NEW FEATURES

LIGHTING

Interior Light

04Z9MO02D

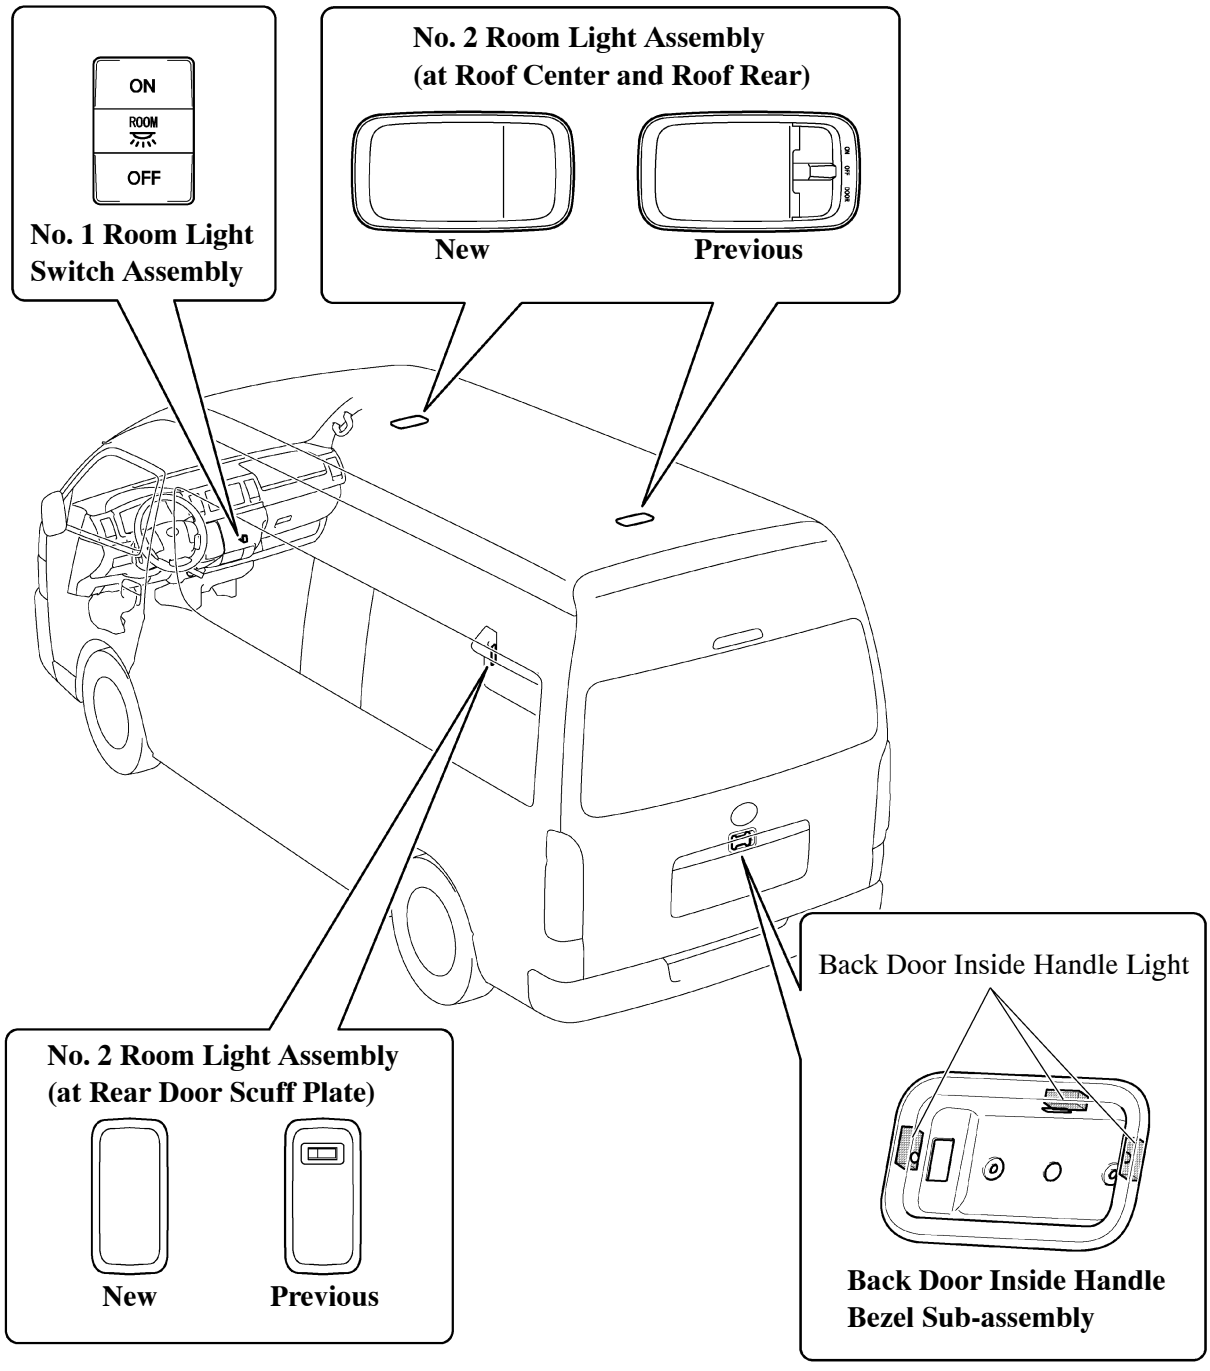
- A back door inside handle lights (LED×3) for the back door inside handle assembly has been provided on the back door inside handle bezel sub-assembly of the Morocco package commuters. The back door inside handle lights will be turned on/off together with the No. 1 room light switch assembly.
- For Morocco package commuters, each light switch of the No. 2 room light assembly (at roof center and roof rear) and No. 2 room light assembly (at rear door scuff plate) has been abolished. Along with this, each room light* on the vehicle rear has been able to turn on/off only with the No. 1 room light switch assembly.

*: No. 2 room light assembly (at roof center and roof rear), No. 2 room light assembly (at rear door scuff plate), and back door inside handle lights.
